**Addendum #01**

**To the project manual and drawings for the:**

**Center Township Trustee  
Emergency Housing Project**

## SECTION "A-A"

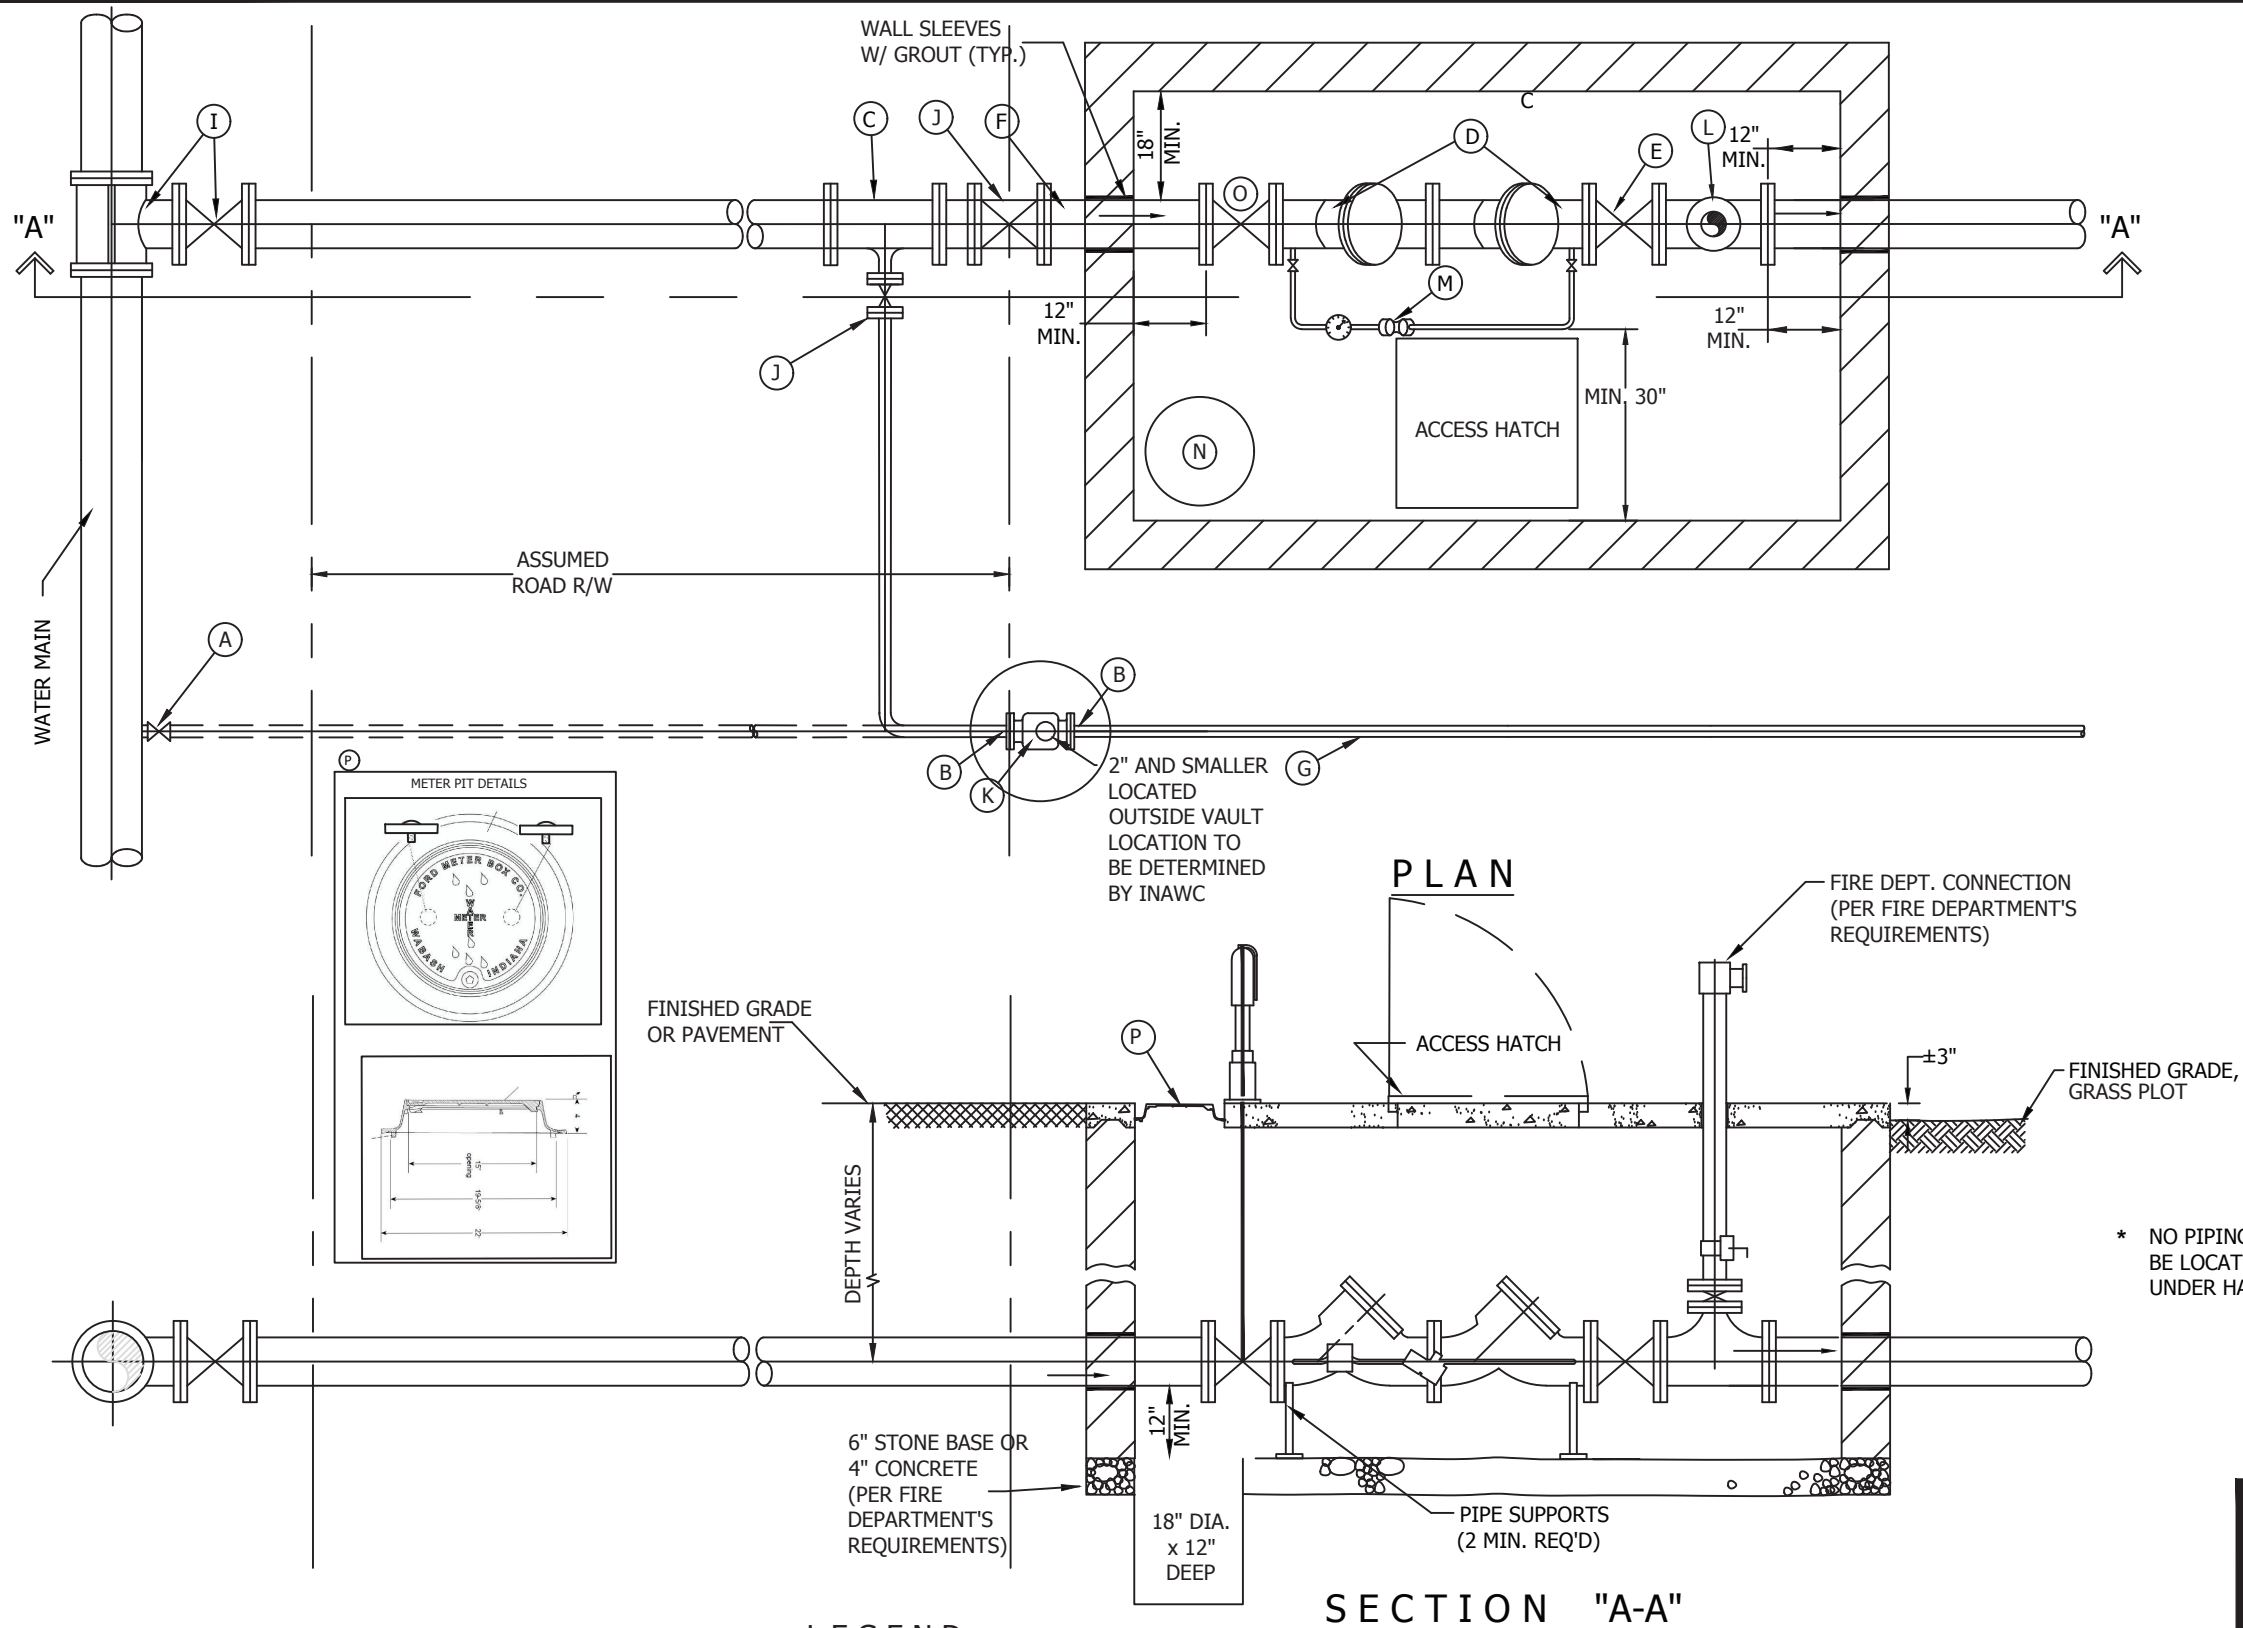
**Item #4: Water Service:**

Water service to the building shall be as follows:

- Single tap at the water main runs to the sprinkler system vault.
- Size of sprinkler service line at vault determined by sprinkler system contractor.
- Domestic water service line of 2" size to branch off main tap before the vault and be directed to 1-1/2" domestic water meter outside of sprinkler vault.
- New domestic water service from meter into facility shall be 2" poly water line with no joints. Provide all valves, back flow preventer, and related equipment as required by local utility service.
- Vault / Tap drawing provided by local utility is attached.
- Any water line supply distribution under the floor slab shall be installed with no joints, splices, connections, or attachments under the slab. Continuous, uninterrupted pipe only under the slab.
- Water supply lines shall be sized as needed for proper function of all fixtures and devices.
